**VOLLMER ROAD  
STA 10+00.00 TO STA 24+00.00**

BY	DATE	No.	REVISION	H-SCALE	V-SCALE	DATE	DESIGNED BY	DRAWN BY	CHECKED BY
				1"=50'	1"=5'	05/13/21	RAB	KRW	
STERLING RANCH - VOLLMER ROAD FILING 2 PLAN & PROFILE									
SHEET 3 OF 11									
JOB NO. 25188.01

STERLING RANCH -  
 VOLLMER ROAD FILING 2  
 SIGNAGE & STRIPING

**VOLLMER ROAD INTERIM CONDITION  
(VALID UNTIL NORTHERN VOLLMER ROAD IS CONSTRUCTED)**

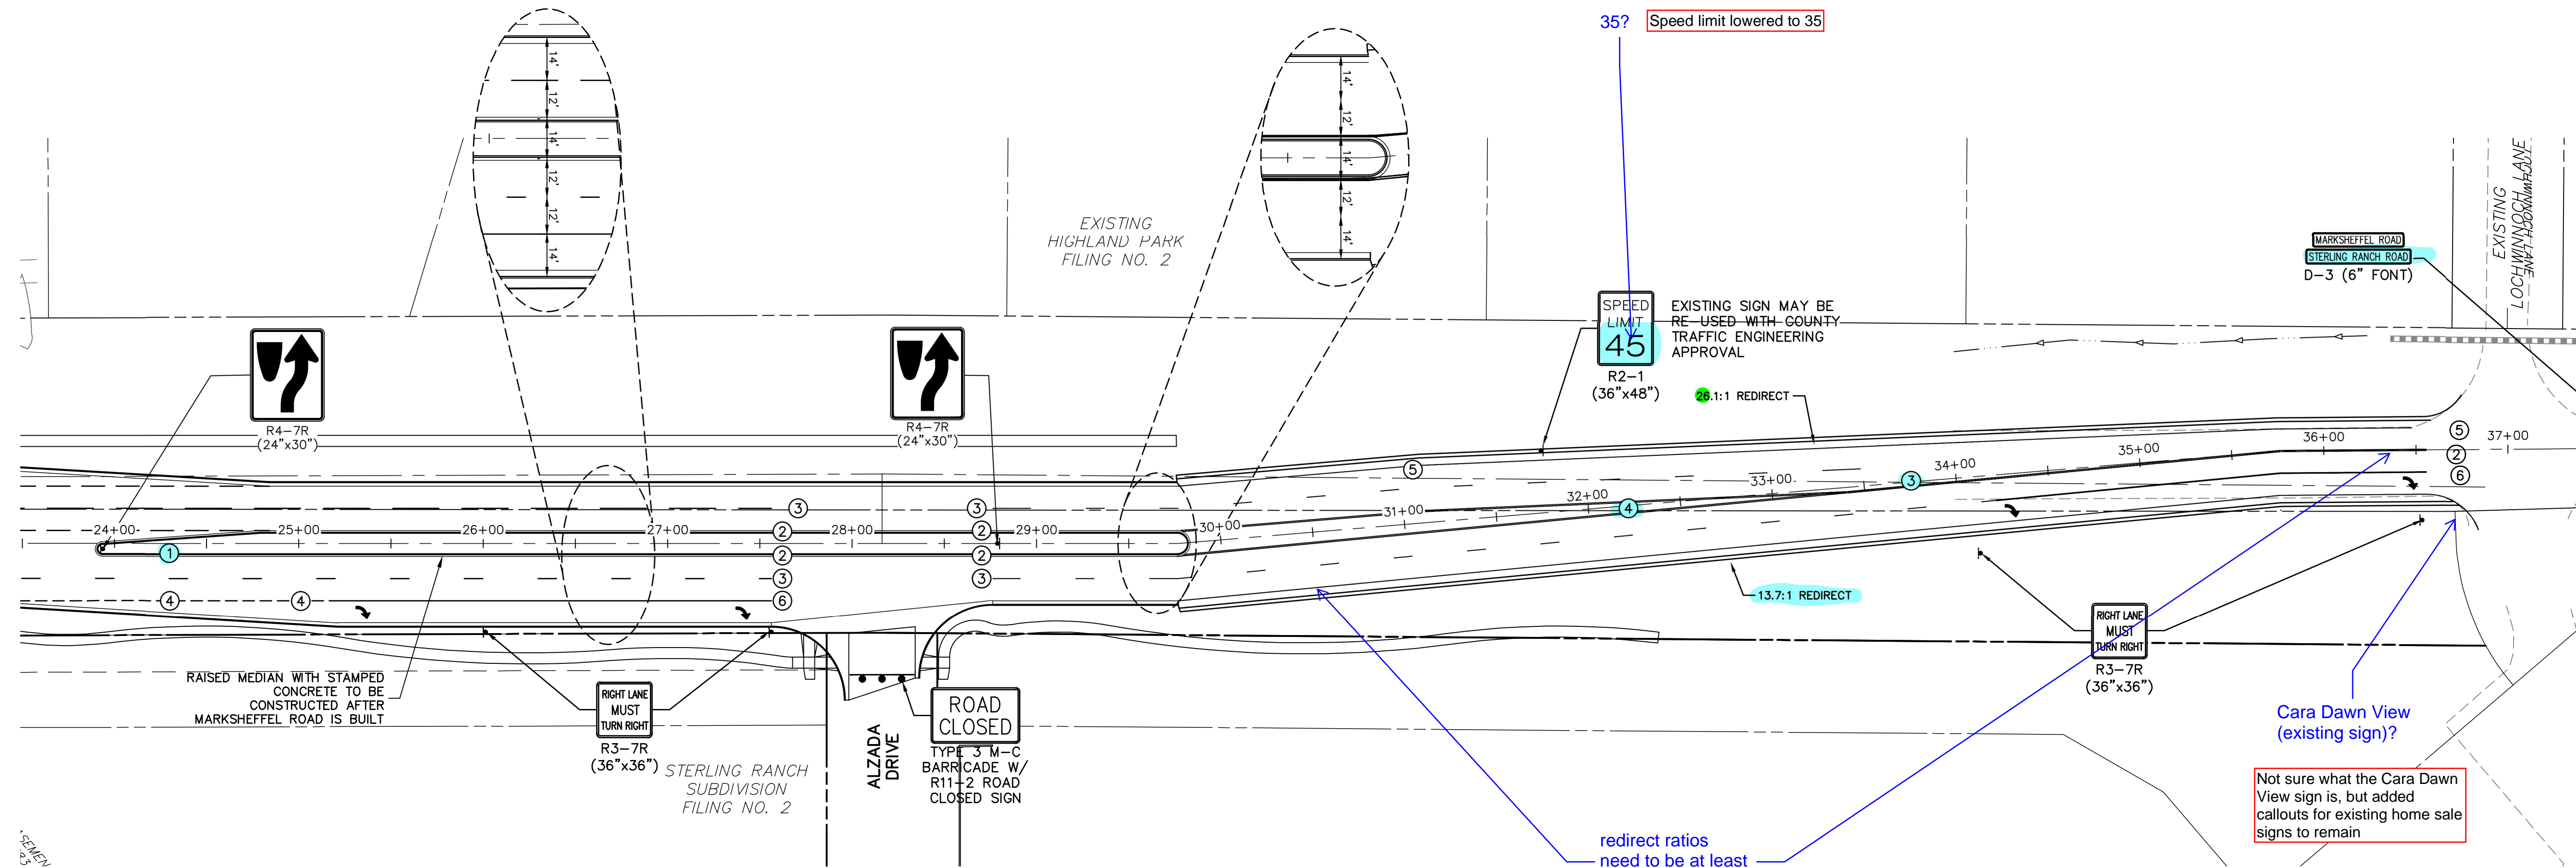
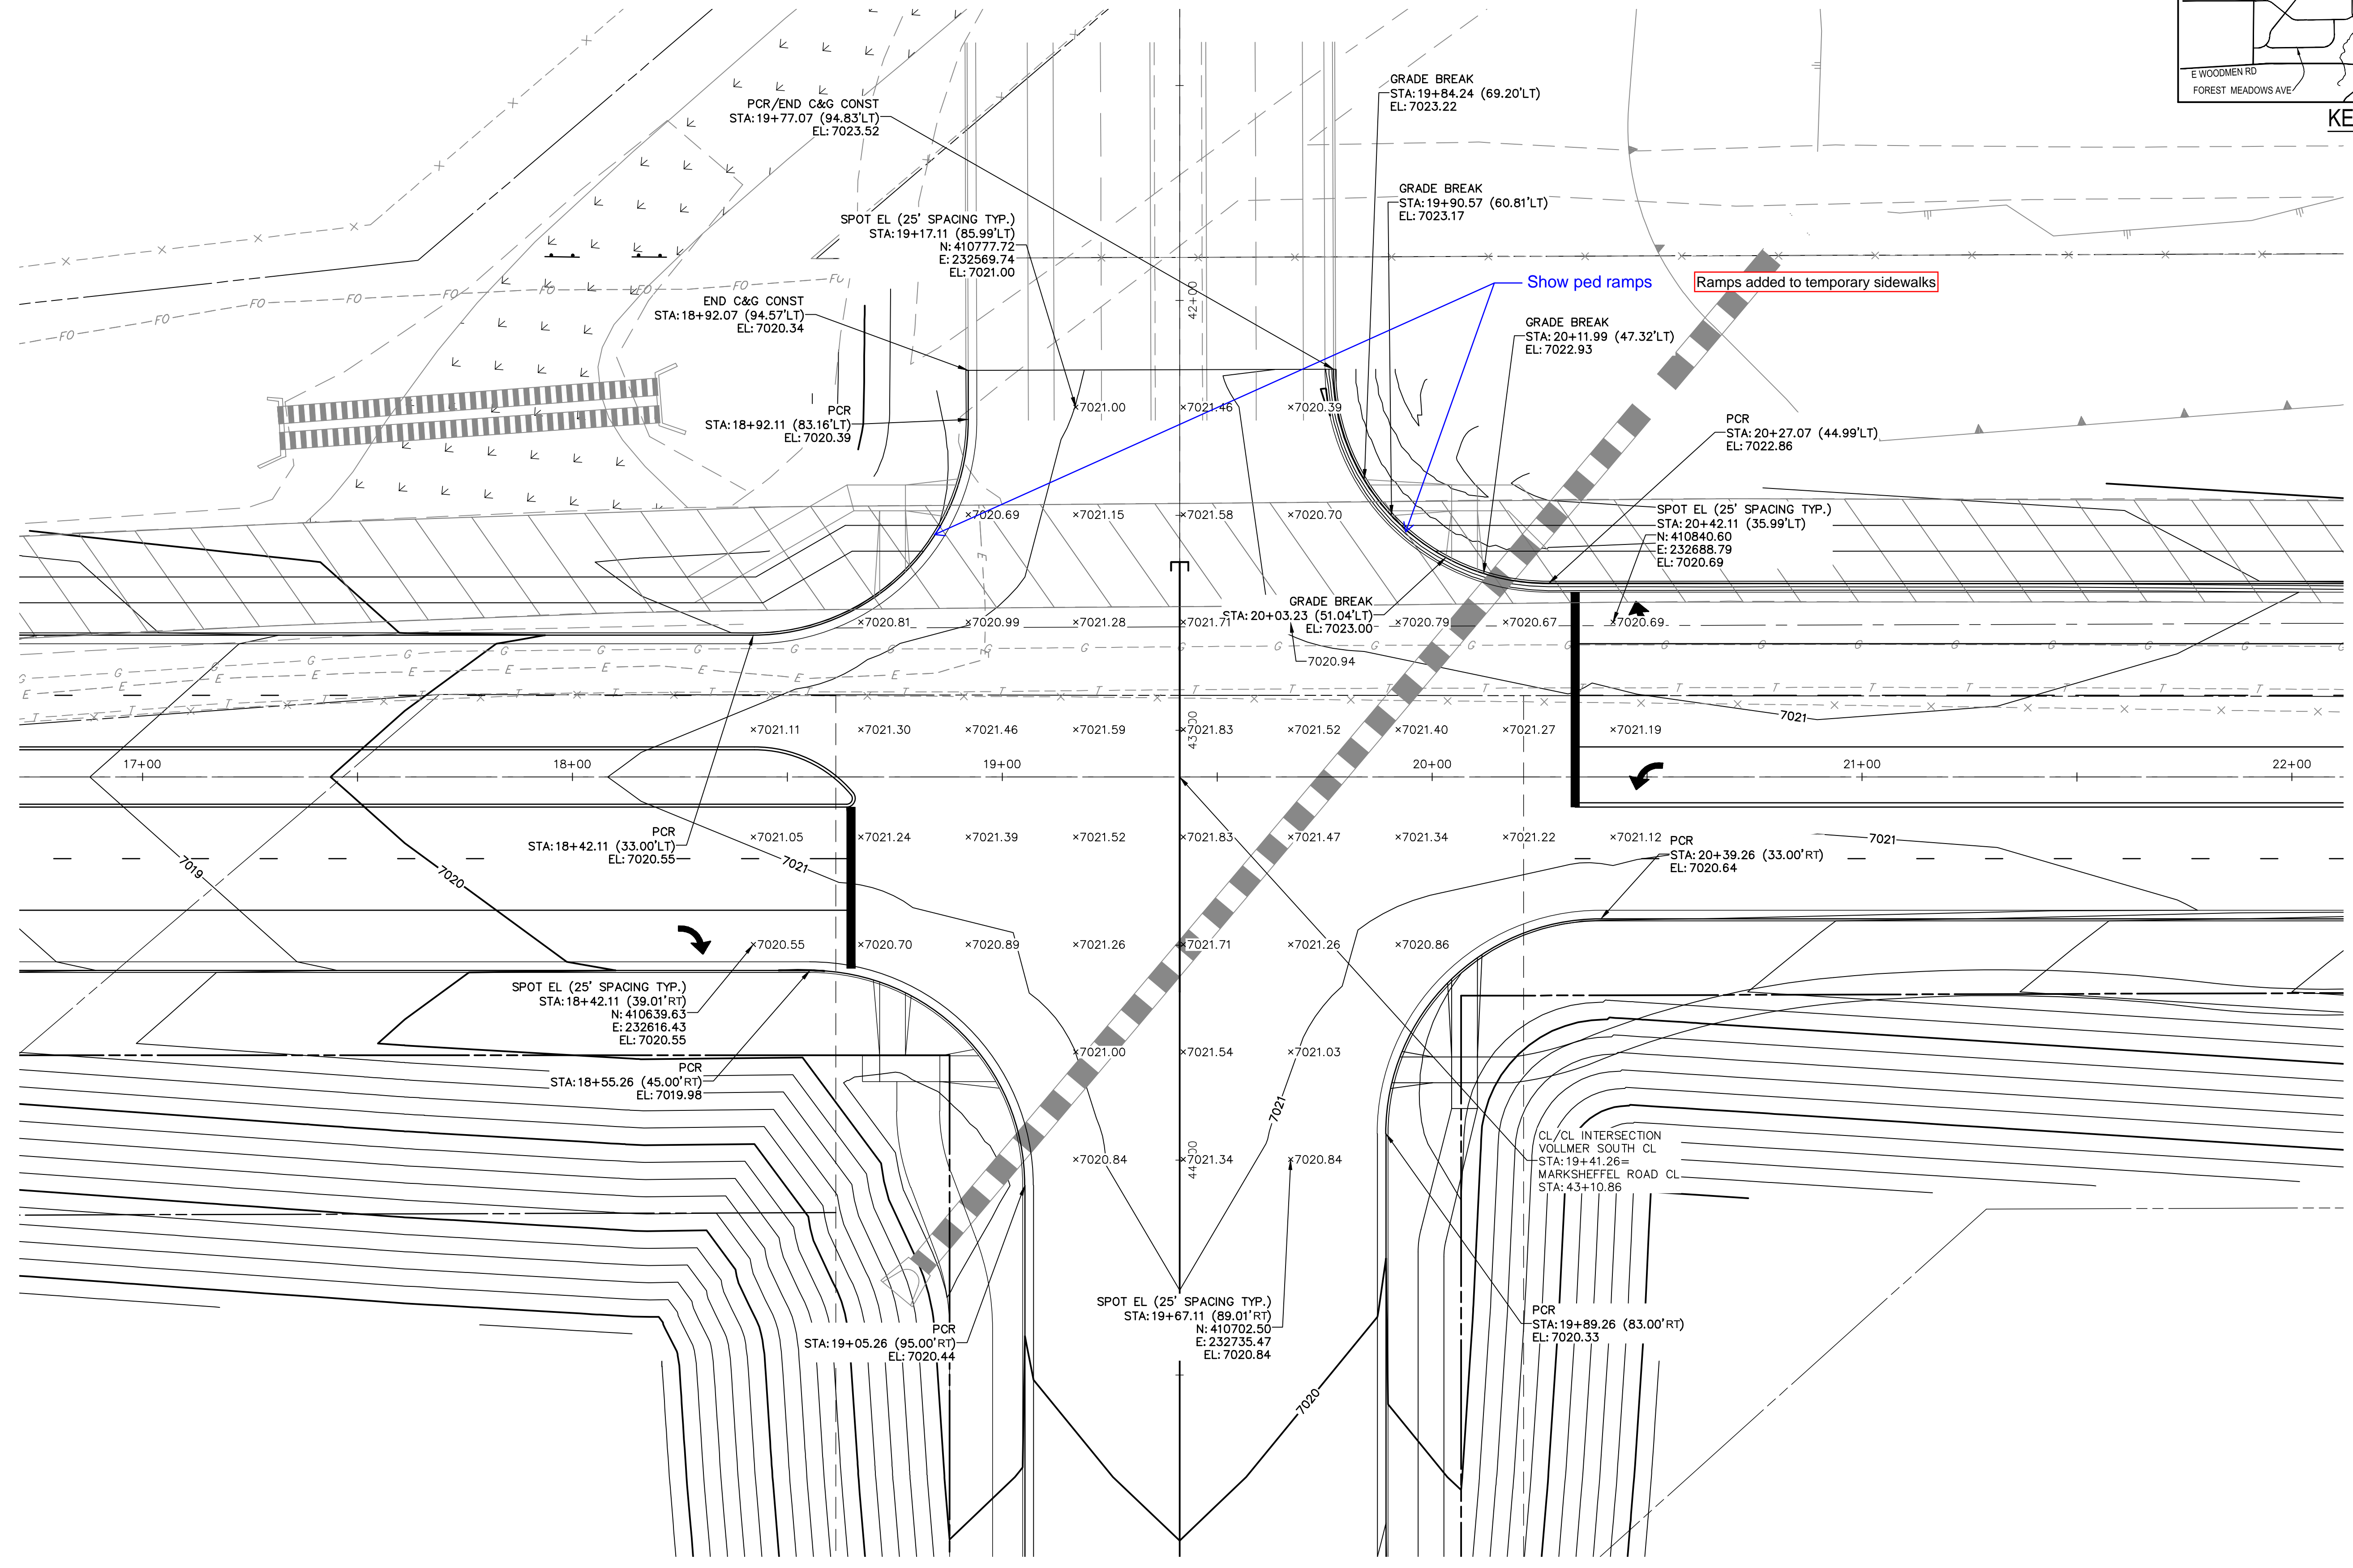
SB taper is 20:1, but NB can only fit 10:1 with ultimate alignment having a 20:1 (but the existing road north of Lochwinnoch only allows for 10:1 NB lane taper in the interim condition)

Not sure what the Cara Dawn View sign is, but added callouts for existing home sale signs to remain
